**Committee of Experts on the Transport of Dangerous Goods  
and on the Globally Harmonized System of Classification  
and Labelling of Chemicals****Sub-Committee of Experts on the Transport  
of Dangerous Goods****Forty-first session**

**Updating the Globally Harmonized System of  
Classification and Labelling of Chemicals:  
physical hazards****Amendments to the classification flow chart/decision logic for  
self-reactive substances and organic peroxides****Transmitted by the International Council of Chemical Associations  
(ICCA)<sup>1</sup>****Introduction**

Figure 2.4.1: FLOW CHART SCHEME FOR SELF-REACTIVE SUBSTANCES

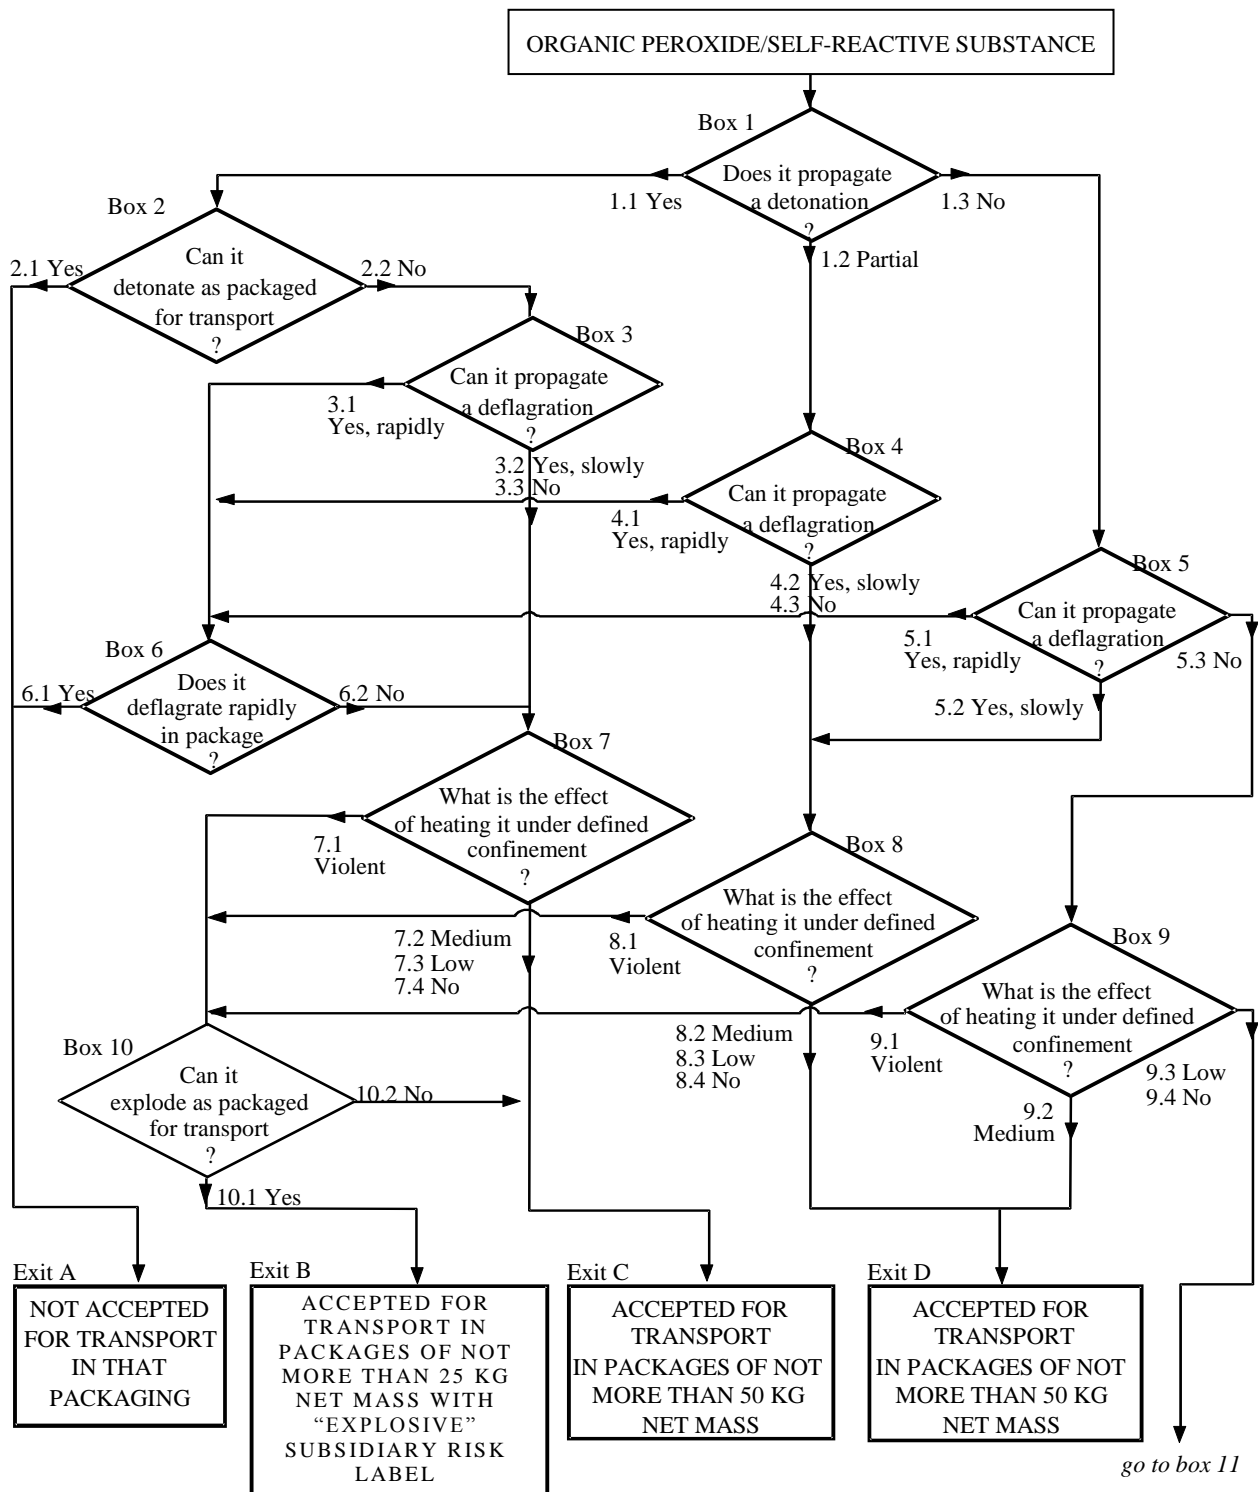
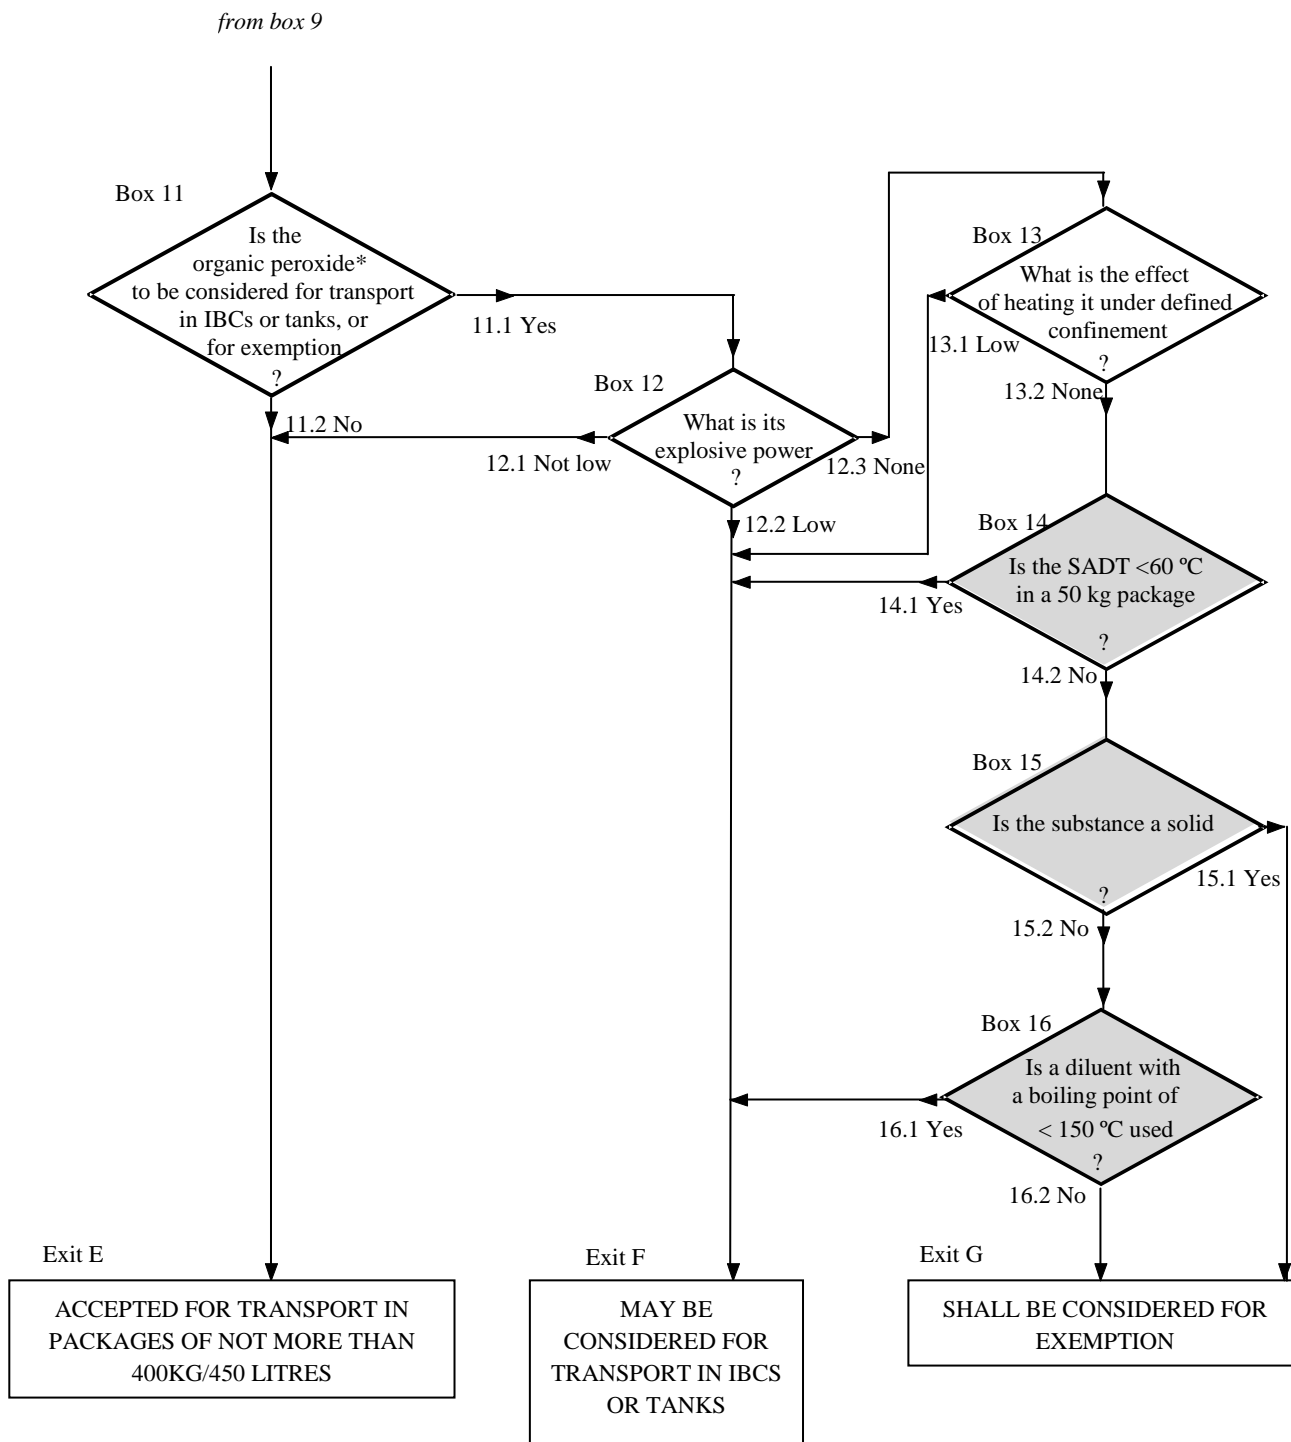
(a) no type G classification possible if the Self-accelerating decomposition temperature (SADT) of the substance is  $< 60\text{ }^{\circ}\text{C}$  in a 50 kg packaging (see Model regulations paragraphs 2.4.2.3.3.2 (g) and 2.5.3.3.2 (g) and GHS paragraphs 2.8.2.2 (g) and 2.15.2.2 (g))

(b) no type G classification possible when a diluent is used with a boiling point  $< 150\text{ }^{\circ}\text{C}$  (see Model regulations paragraphs 2.4.2.3.3.2 (g) and 2.5.3.3.2 (g) and GHS paragraphs 2.8.2.2 (g) and 2.15.2.2 (g))

8. In the proposed amended flow chart these two aspects are addressed in the new boxes 14 and 15 respectively. The introduction of these boxes will not lead to a change in the existing classification principles.

(a) In the Chapters 2.4 and 2.5 of the Model Regulations replace Figures 2.4.1 and 2.5.1 by the following:

Decision logic 2.8 for self-reactive substances and mixtures  
Decision logic 2.15 for organic peroxides

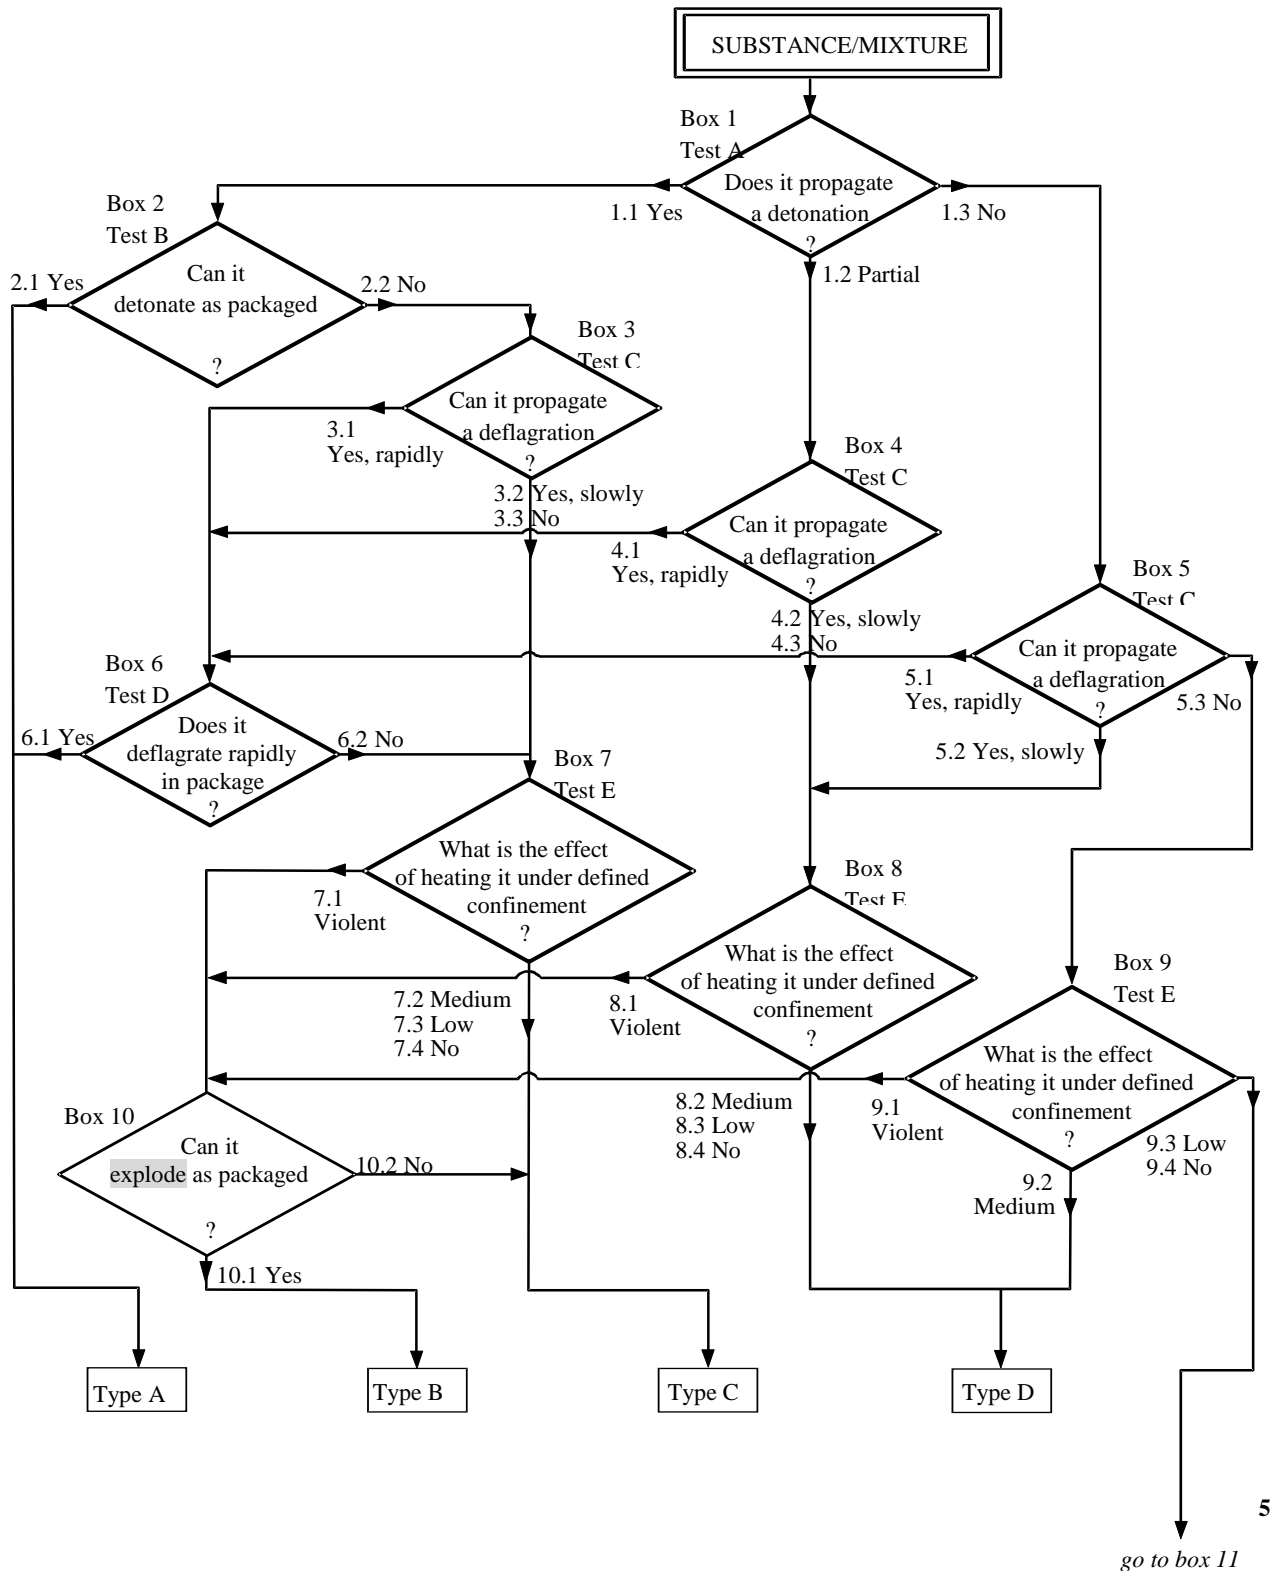
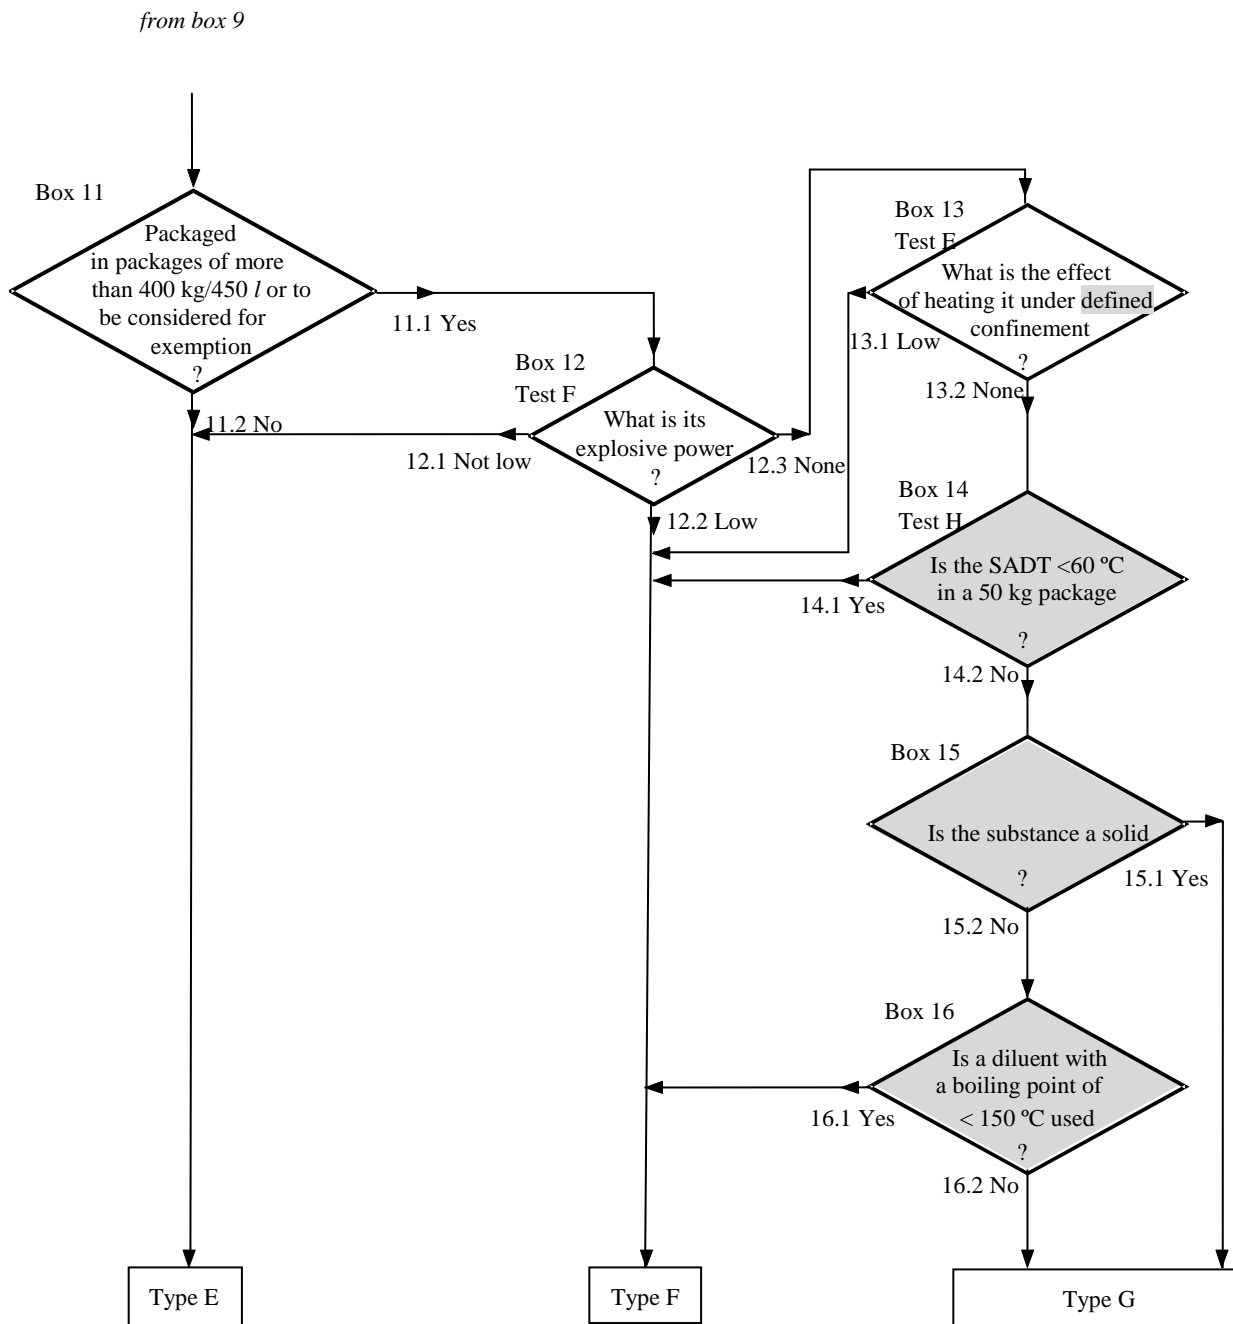
(b) In Chapters 2.8 and 2.15 of the GHS replace decision logics 2.8 and 2.15 by the following:

(Note: the grey shaded wording in boxes 10 and 13 are just corrections.)
